# Work Order ID 95324

Item Name: Crosstube Turning Detail

<b>DART AEROSPACE LTD</b>	<b>Work Order:</b>	<b>95324</b>
<b>Description:</b> Crosstube Assembly	<b>Part Number:</b>	<b>D206-667-243</b>
<b>Inspection Dwg:</b> D206-667-243 <b>Rev:</b> C		<b>Page 1 of 2</b>

DRAWING NO. D206-667-243	TITLE CROSSTUBE ASS'Y (206L HIGH AFT)	REV. C	<b>DART AEROSPACE LTD ENGINEERING ORDER</b>		D.E.O. NO. D206-667-243-C-1	SHEET NO. SHEET 1 OF 1	SCALE NTS
DRAWN 92	CHECKED ASS	MFG. APPR. RB	APPROVED MD		DE APPR. H		
DATE 11.07.15	DATE 11.07.20	DATE 11.07.21	DATE 11/07/21		DATE 11.07.21

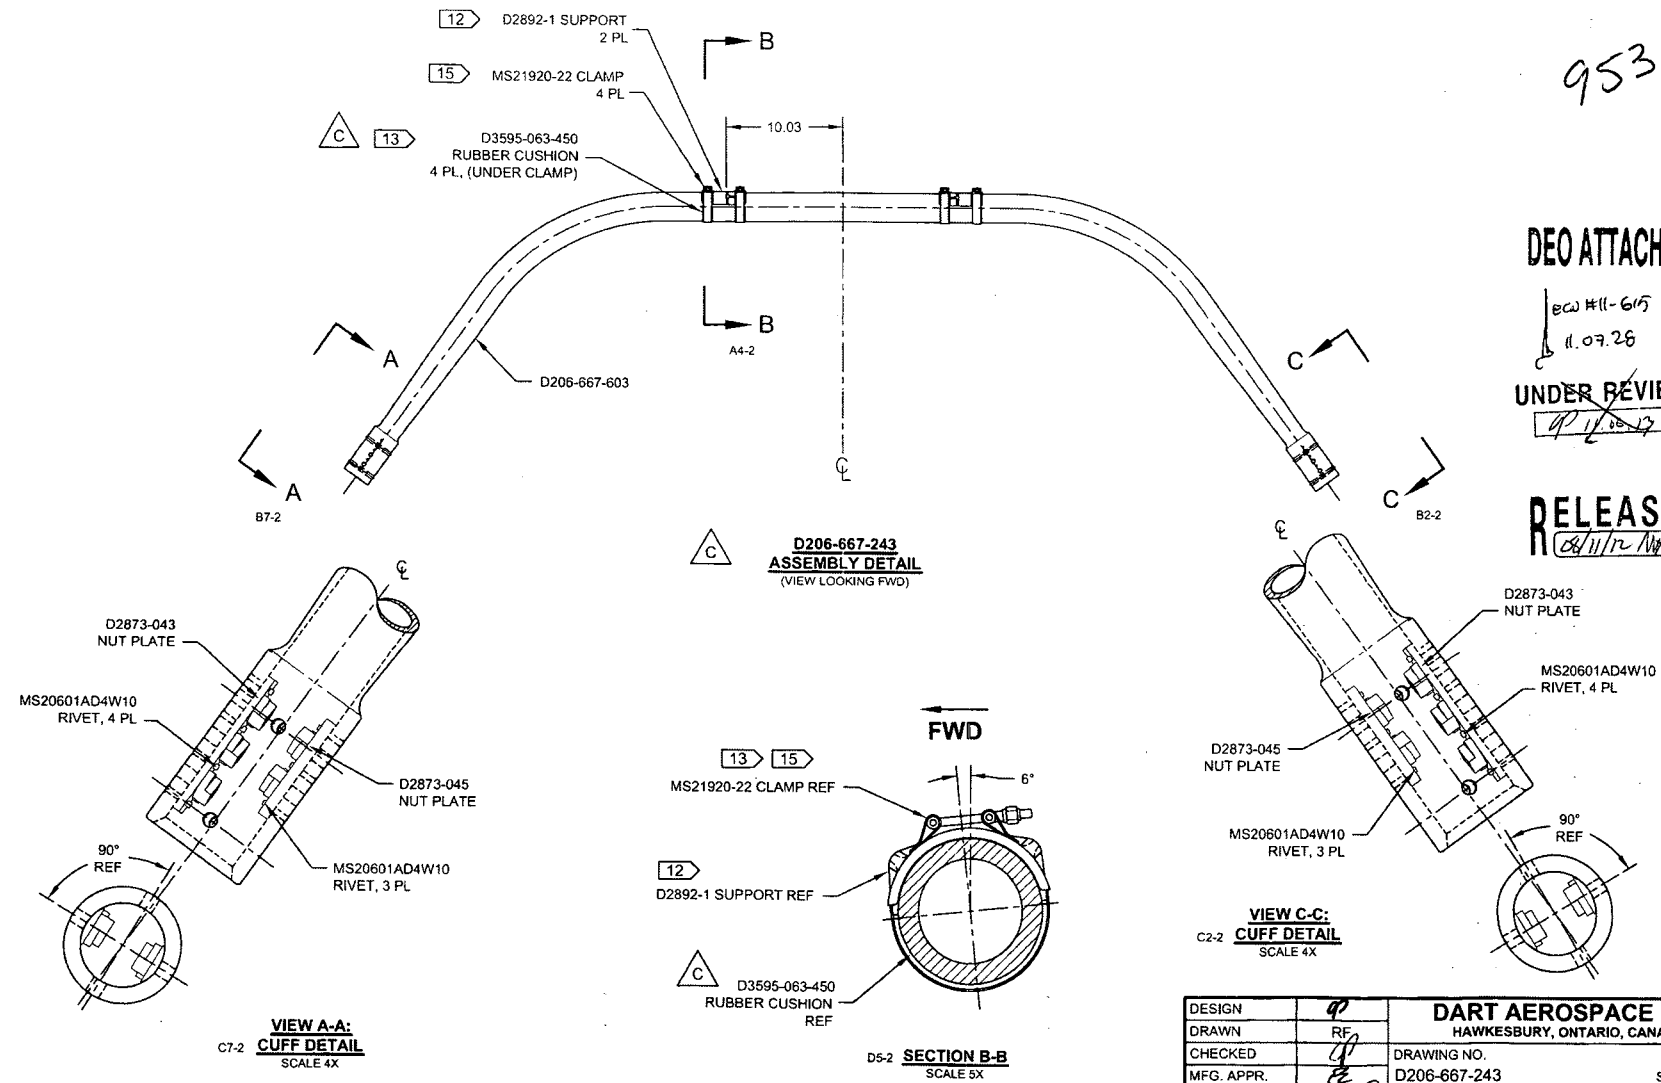
REPLACE MAGNOBOND WITH PROSEAL.

NOTE 12 & 15, SHEET 1 IS AMENDED AS FOLLOWS:

- 12) TO INSTALL D2892-1 SUPPORT: ABRAD MATING SURFACE OF SUPPORT AND CROSSTUBE WITH 180-GRIT SANDPAPER AND REMOVE RESIDUE WITH MEK (OR EQUIVALENT). APPLY A 0.04" TO 0.07" THICK LAYER OF PROSEAL 890 CLASS B-2 (OR AMS-S-8802 CLASS B-2) SEALANT TO MATING SURFACE OF SUPPORT.
- 15) TORQUE CLAMPS 80 TO 100 IN-LB. ENSURE AT LEAST 1.5 THREADS SHOWING IN SAFETY AND THAT NUT HAS NOT BOTTOMED-OUT AFTER TORQUING. **PRIOR TO PACKAGING, RE-CHECK TORQUE ON CLAMPS AFTER PROSEAL 890 SEALANT HAS CURED FOR 72 HOURS.**
